**ADDENDUM NO. 2**

**PALOLO VALLEY HOMES MODERNIZATION, PHASE 3**  
HONOLULU, OAHU, HAWAII  
Tax Map Key No.: (1) 3-004-015

HPHA Job No. 15-016-108-Z  
IFB-CMB-2016-17

May 27, 2016

DRAWING NO.: A-101  
 SHEET: 24 OF 38

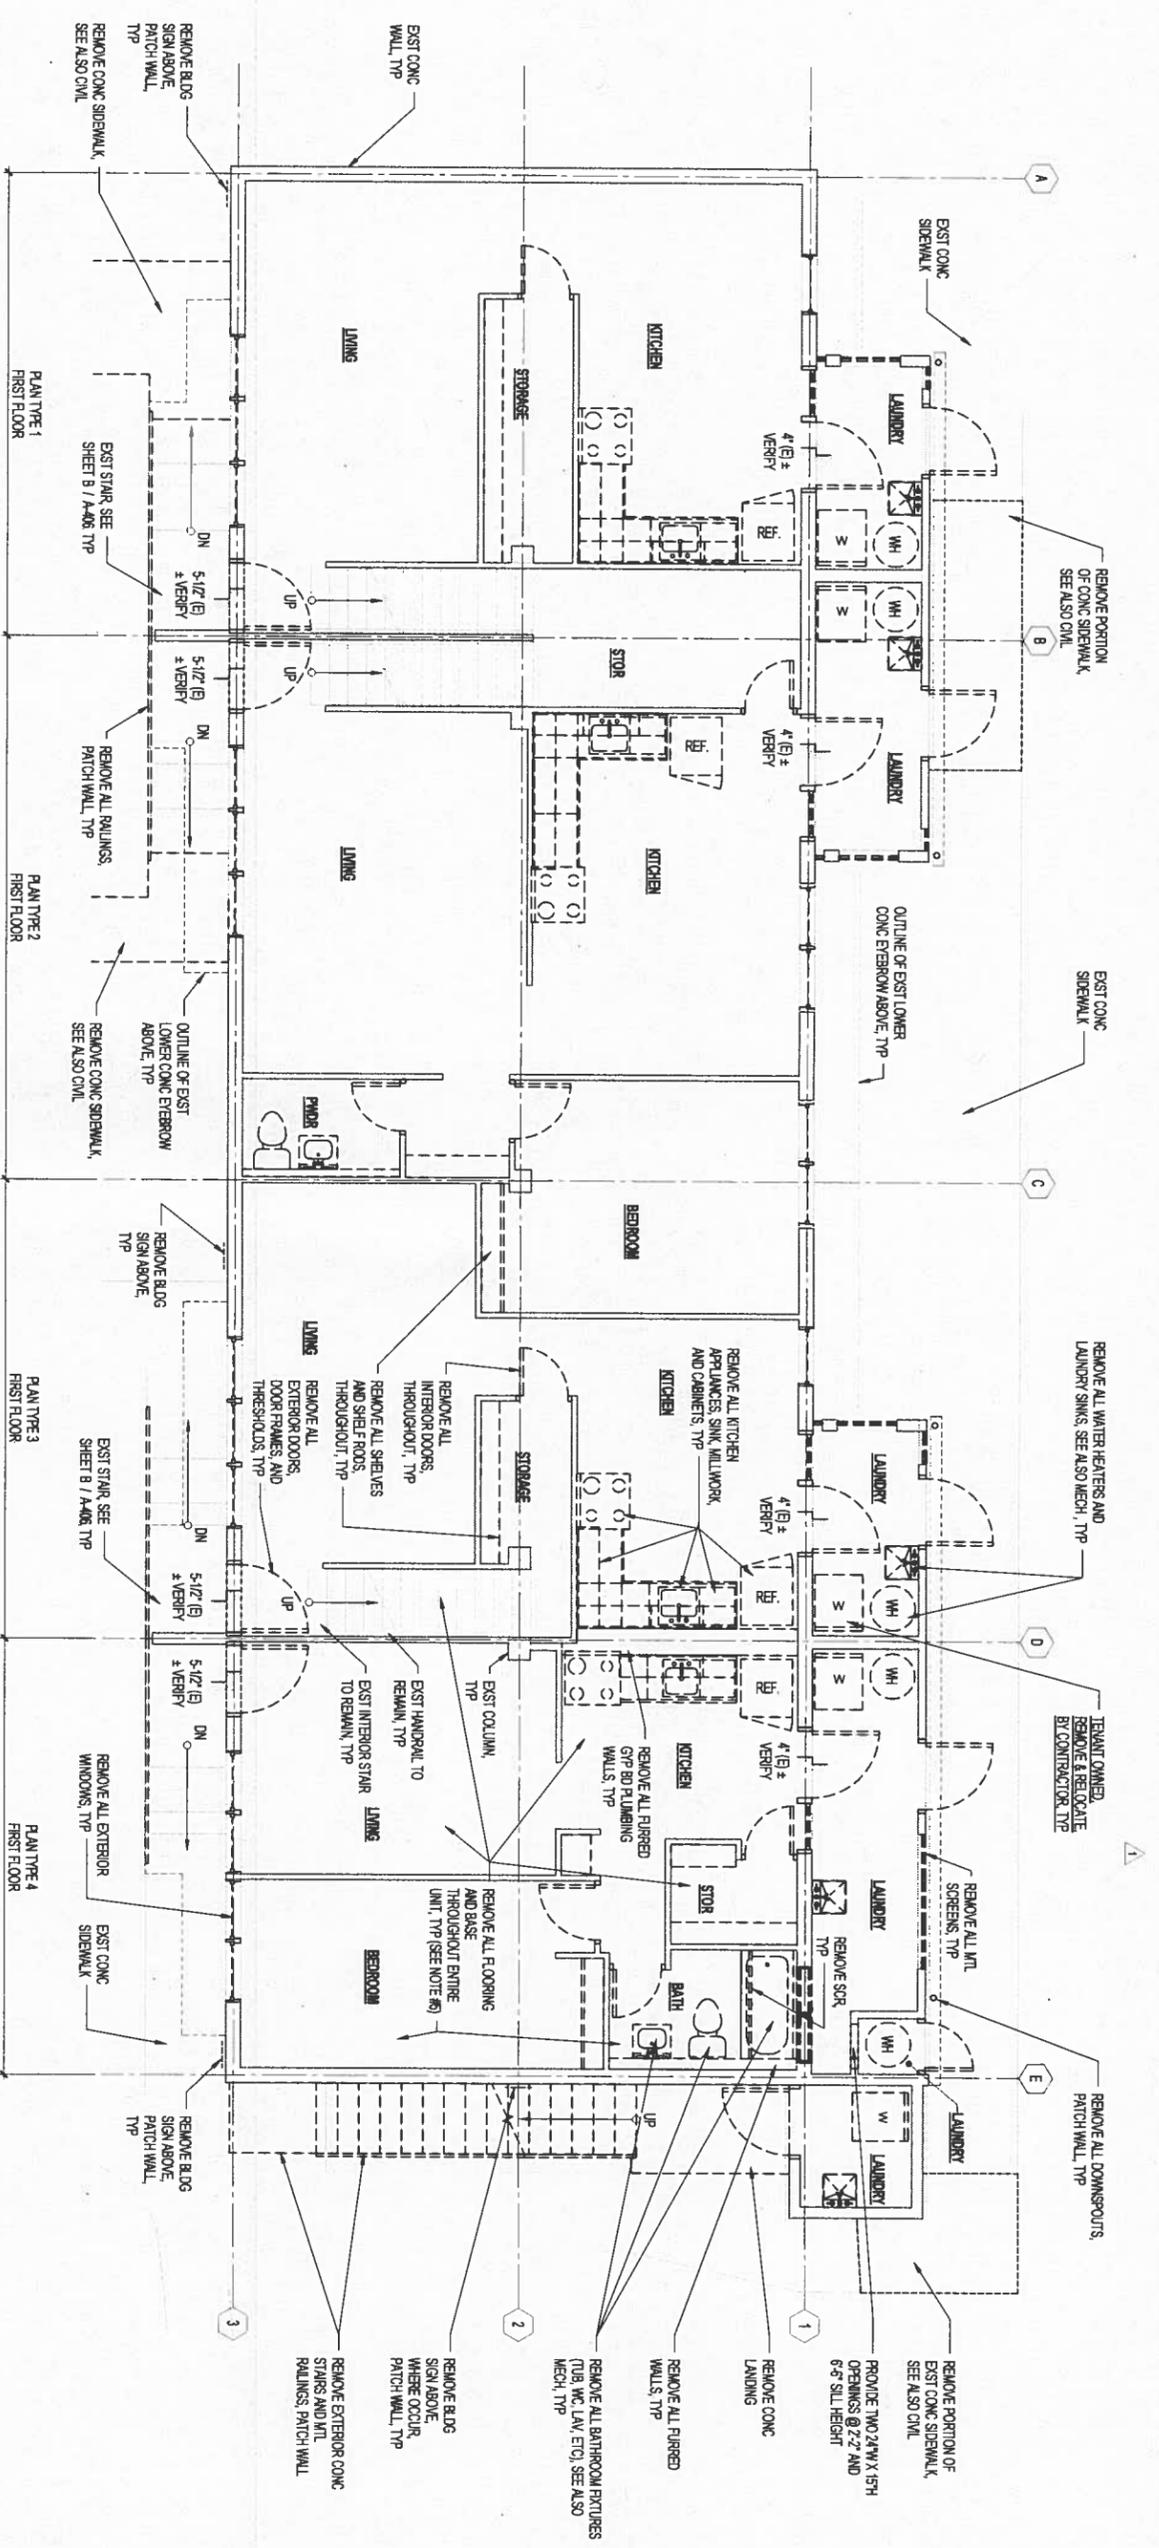
- b. Revised details.
8. Drawing No. C-503
- a. Added Note 5 to typical clothesline pad detail.
  - b. Added Limits of Grading to grading sections.
9. Drawing No. A-101

- a. Revised Note.
10. Drawing No. A-102
- a. Revised Note.
11. Drawing No. A-103
- a. Revised Note.
12. Drawing No. A-104
- a. Revised Note.
13. Drawing No. A-105

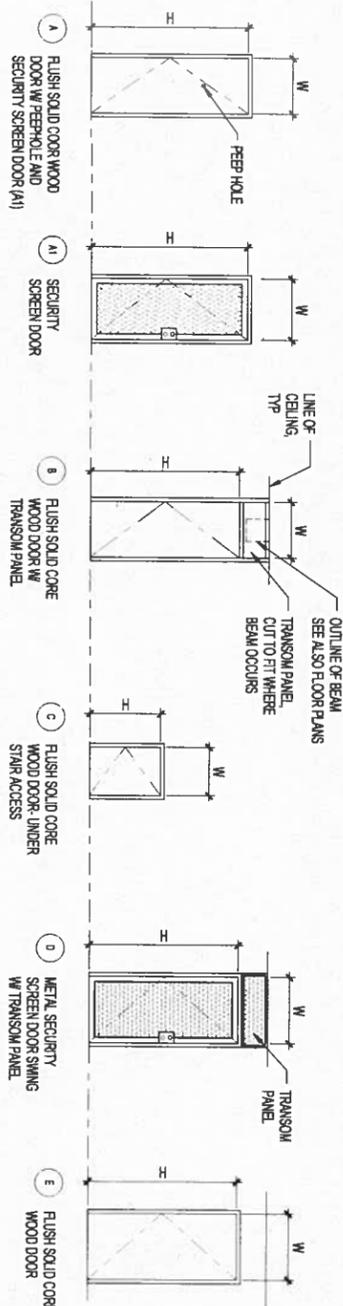
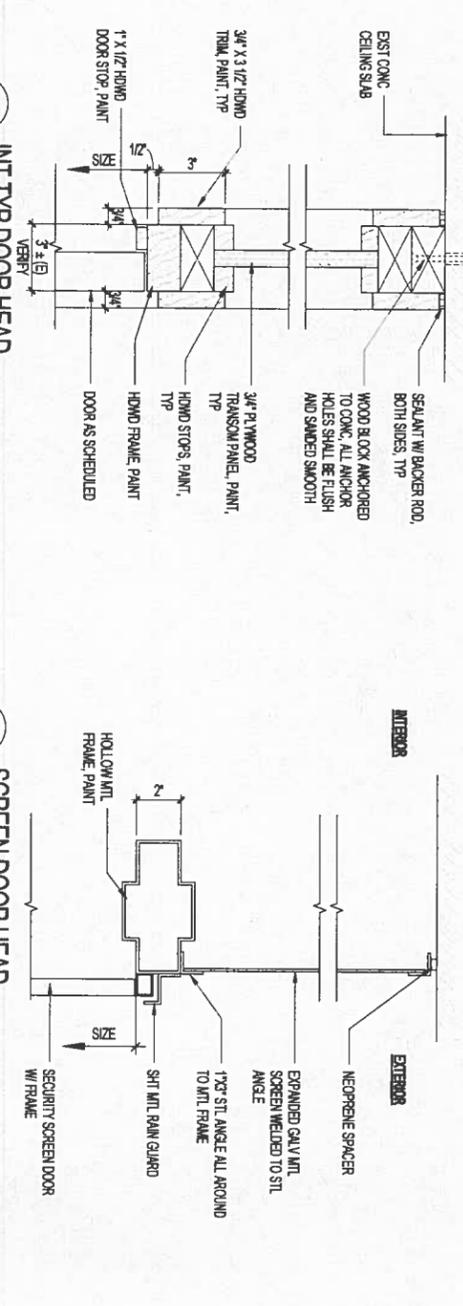
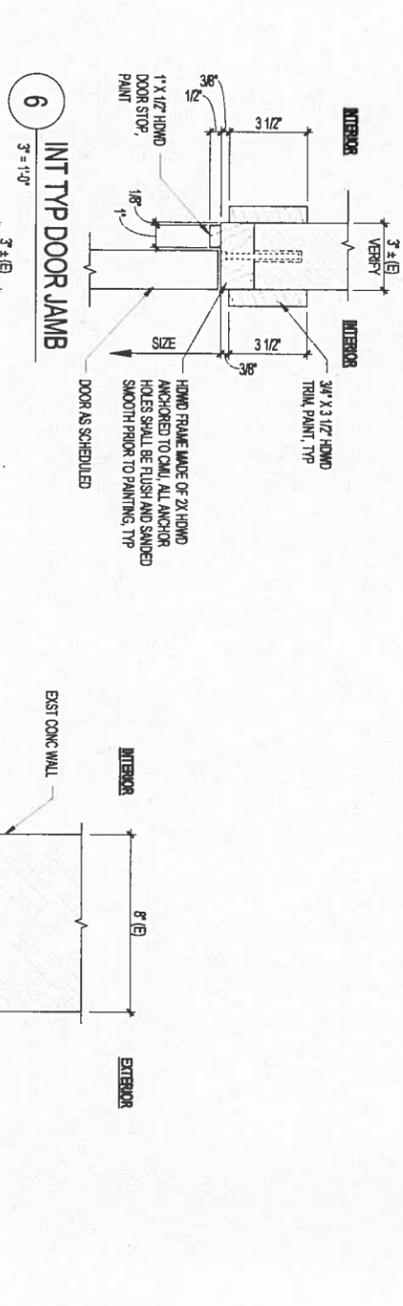
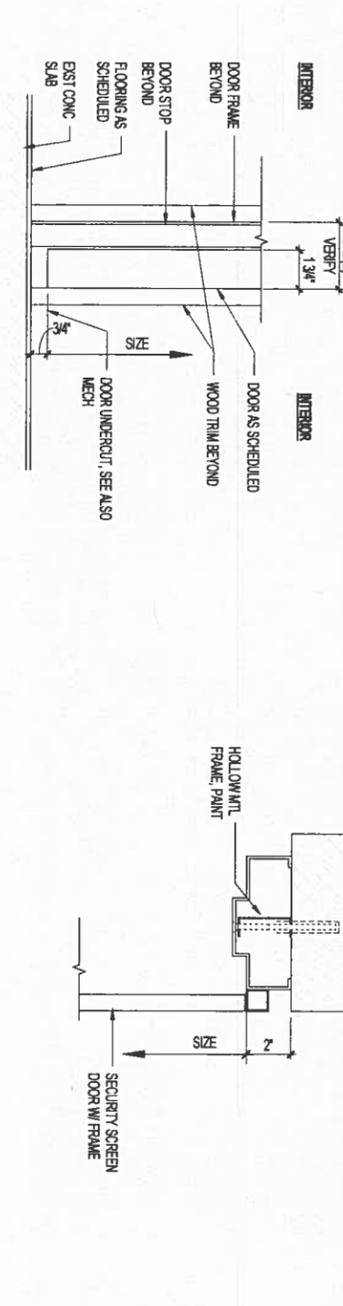
- a. Revise door no.
14. Drawing No. A-106
- a. Revise door no.
15. Drawing No. A-602
- a. Revised door schedule.

**1 PARTIAL SITE ELECTRICAL PLAN**  
 E11 SCALE: 1" = 20'-0"

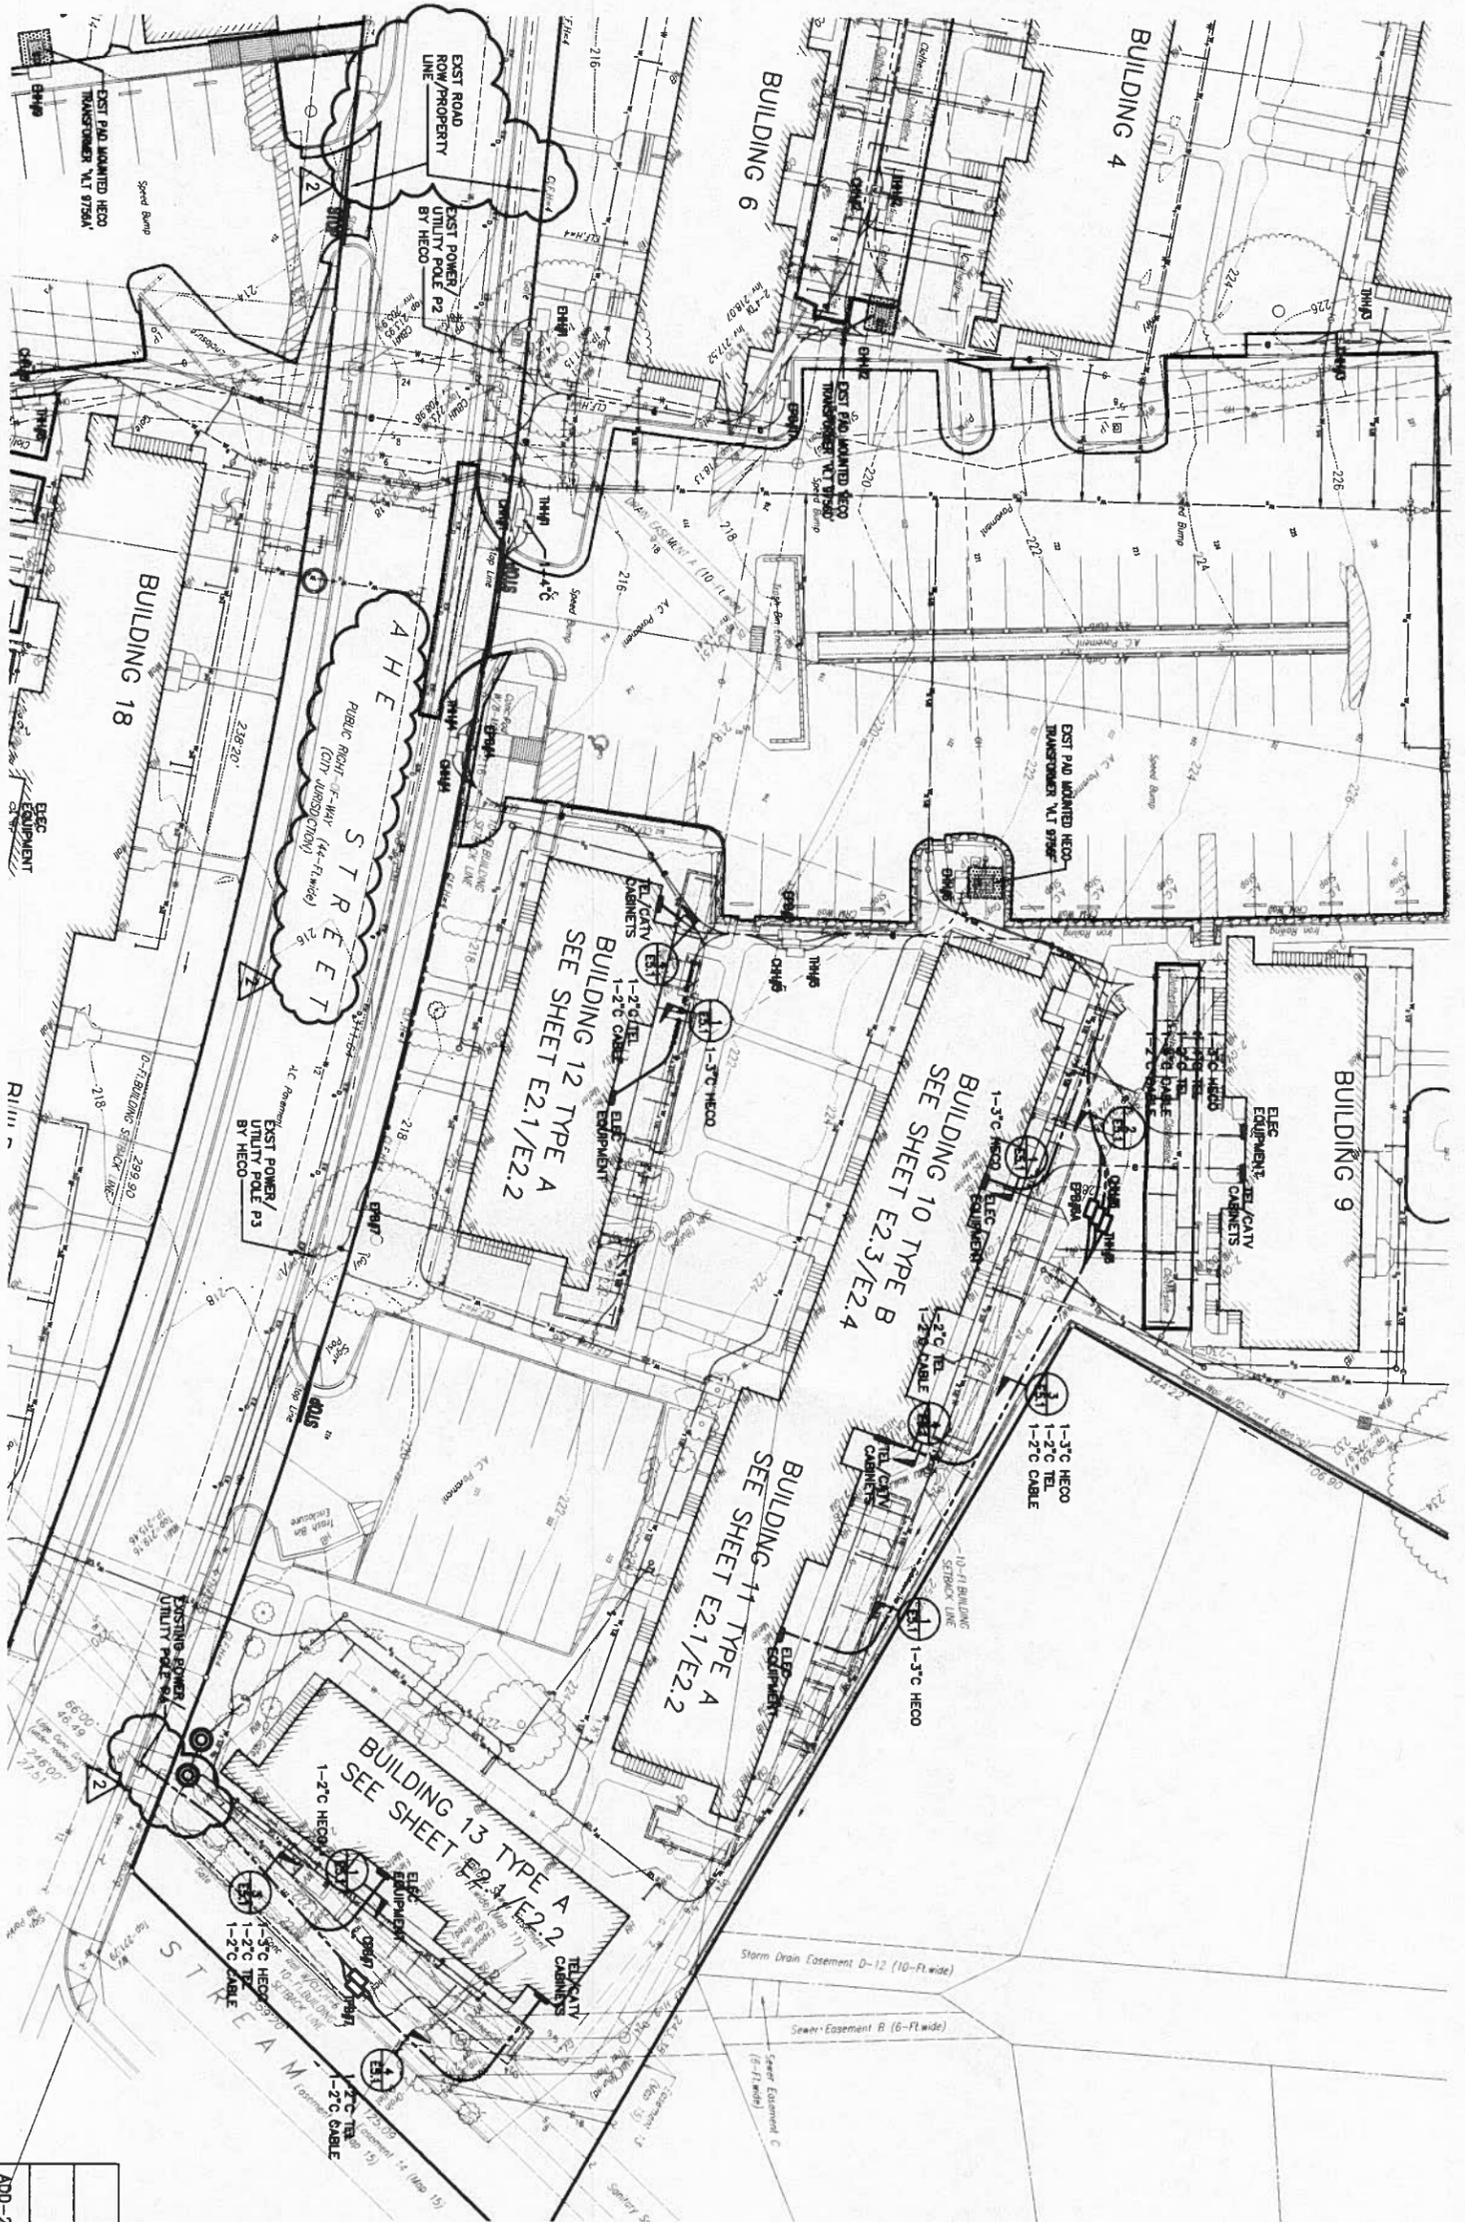
16. Drawing No. E1.1
  - a. Reroute electrical line.
17. Drawing No. E5.1
  - a. Added CEB approval block.
